RECORD OF DECISION AMENDMENT

AVCO LYCOMING SUPERFUND SITE

April 2000

**RESPONSIVENESS SUMMARY
FOR THE PROPOSED PLAN FOR A CHANGE IN REMEDY
FOR THE AVCO LYCOMING SUPERFUND SITE**

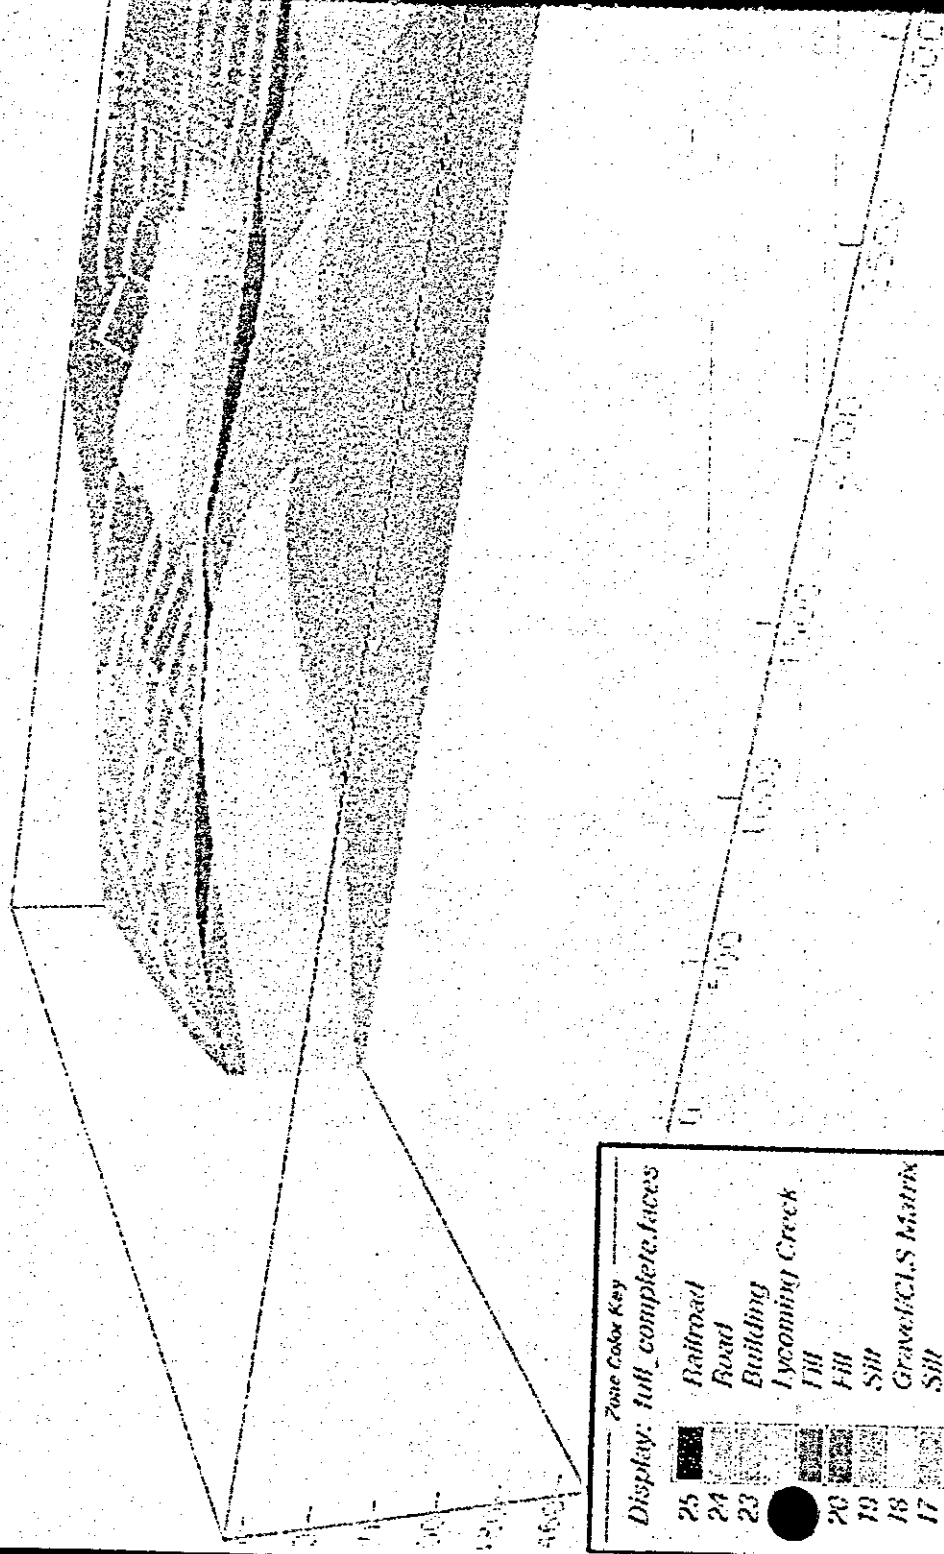
8. Re:Figure 2, there are no street names to orient the reader; a larger map of Avco should show the features subsequently discussed (i.e., the central section, the east parking lot, the north/south stream channel)

9. Figure 2, in comparison with an earlier one the 3rd quarterly report of July 1992, from the ERM Group, lacks noting the MW-10 in the upper left hand corner. If maps from one year to another do not agree with what is/is not present, confusion results. Perhaps some table can note what types of wells are noted with what nomenclature, when they first were

drilled and thus first appeared on the map, when they were disbanded, what they were used for, etc. The map legend could be more complete (e.g. the PADEP officer present at the 1/10/00 meeting said an air stripper southwest of PW-9 was deleted from Figure 2). Inaccurate maps do not lend credibility to the EPA and lead to a lack of confidence in the EPA by residents. Note too that some MW-designations are followed by letters, others by numbers, raising a question as to what the difference is.

10. Figure 2: Confusion exists to what the property line of Avco is, inasmuch as it is said they purchased homes along Oliver St., and then razed them. A line should demarcate what the Avco-owned property is. It should be made clear that the Superfund Site is not identical with the Avco property site; perhaps the Superfund Site should be re-named so it is understood it goes beyond the Avco property lines.

11. Figure 2: The beltway (U.S. Interstate 180, State Routes 220 and 15) isn't shown on figure 2 (but is on figure 1, the previous page). The beltway should be on figure 2, especially to show what items in the legend are in relationship to the beltway. It has been said some wells are below the beltway.

28. Are all said strippers noted on Figure 2?

165. Re: the Legend for Figure 2, please more clearly distinguish the definitions and locations and numbers of the monitoring wells, the pumping recovery wells, the site recovery wells, the strippers. What is a pump and treat well? What is an extraction well? Is the RW-2 a pumping recovery well? Are there only RW-1, RW-2, RW-3 on Avco property? How many Site Recovery wells are there? What is the abbreviation for Site Recovery well? I assume RW means a Pumping Recovery Well. Are WMWA wells identified as Pumping Wells (PW)? Are PW-7 and PW-8 located within Lycoming Creek? What is the dark circle on the southern-most bridge? Where is the pipe located that discharges water into the Lycoming Creek? Can you have an enlarged/magnified map showing what would appear if the proposed plan is adopted, especially on the hard-to-read Containment Zone.

EPA Response: The Figure was updated in the ROD Amendment taking this comment into consideration.

EPA Response: Figure 2 was used to identify where the Site is located in relation to local landmarks. The Figure was updated in the ROD Amendment taking this comment into account.

EPA Response: Street names have been added to Figure 2. Inclusion of the beltway on Figure 2 would change the perspective that the EPA was trying to identify.

EPA Response: In addition to the two off-site strippers, two on-site strippers are used to treat water from RW-1 and RW-2. These wells are shown in Figure 2.

EPA Response: Several of the wells are shown on figure 2, labeled PW-3, PW-4, PW-7, PW-8 and PW-9. The remaining supply wells are shown located farther south then the map extends. The well field straddles Lycoming Creek below Third Street. The WMWA can supply you with more specific information as to the precise size of the well field.

EPA Response: Figure 2 was intended to provide a reference as to where the Site was located in relationship to the neighborhood.

FIGURE 1

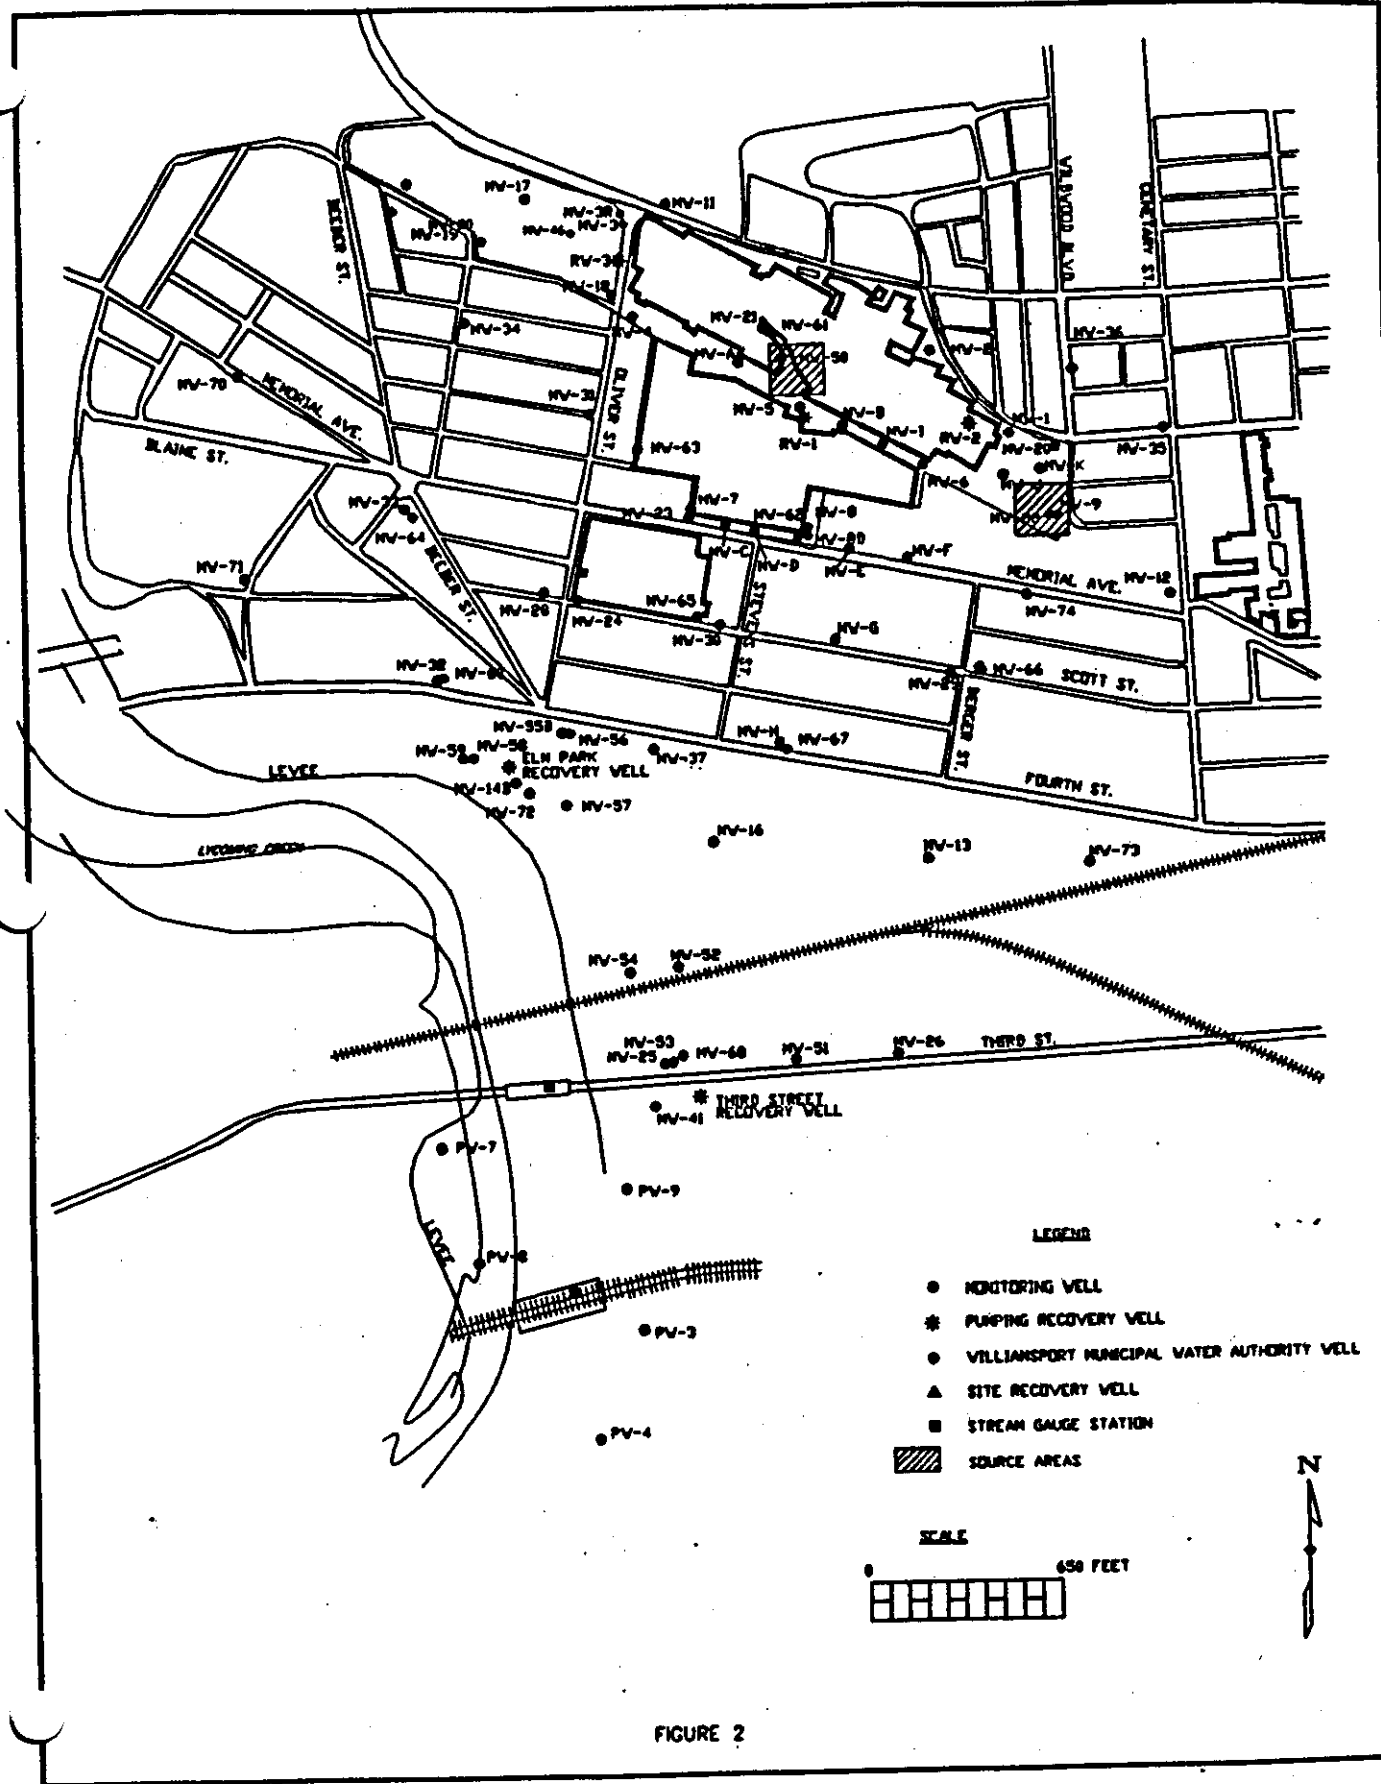
38. Kindly identify the geologic conditions, the VOC plume, and the mid-site migration pathway associated with a north-south buried stream channel, in separate maps attached to the proposed plan and ROD.

EPA Response: Please refer to Figure 1 in the ROD Amendment.

EPA Response: The statement should have said, "to create a barrier to further off-Facility migration.." Refer to Figure 1 in the ROD Amendment.
